C.N.R. OVERHEAD

GENERAL PLAN

FOUNDATION INVESTIGATION REPORT
For
Proposed Crossing at C.N.R. & Hwy. 54
Proposed Revision Line 'L'
Township of Onondaga - County of Brant
District No. 4 (Hamilton)
W.J. 69-F-25 -- W.P. 310-66

Re: Proposed Overhead Bridge on Highway 54, Cainsville, Ontario Mile 71.78
Dunnville Subdivision.

ELEVATION Δ-A
SCALE: 1"=20'-0"

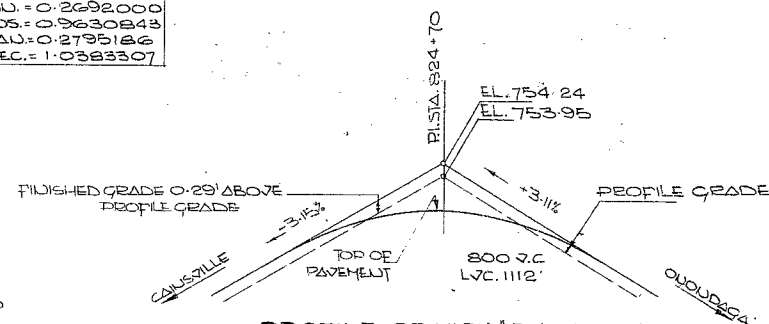
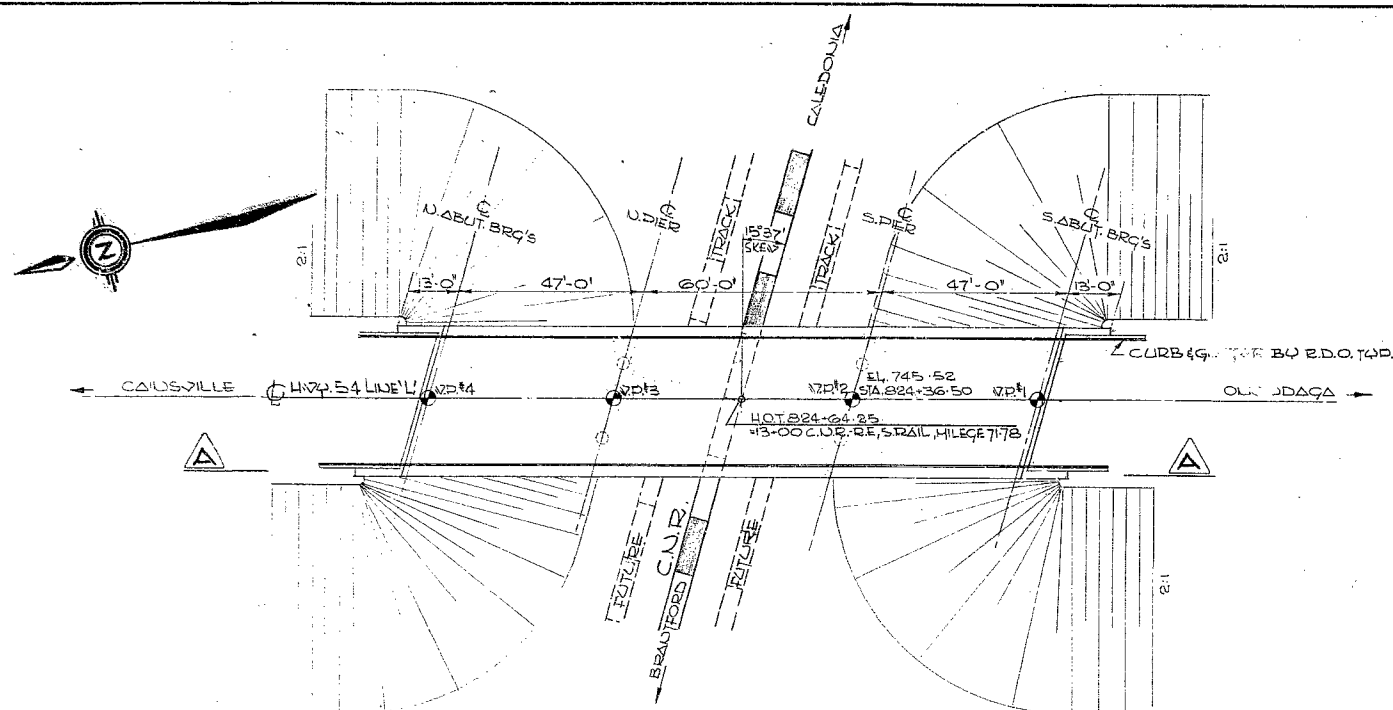
Although not required by the requirements of Board Order E-5, it has been your custom to include a profile of track at a bridge location along with the profile of the proposed roadway. Please arrange to show the profile on Drawing D-6720-1, and also verify that elevation of profile grades at P.I. Station 824 + 70 is to be EL. 754.03, not EL 753.95.

There is not enough data available to establish the railway profile. However, the top-of-rail elevations are added on the plan.

The profile grade elevation at P.I. station 824+70 has been updated to 754.03.
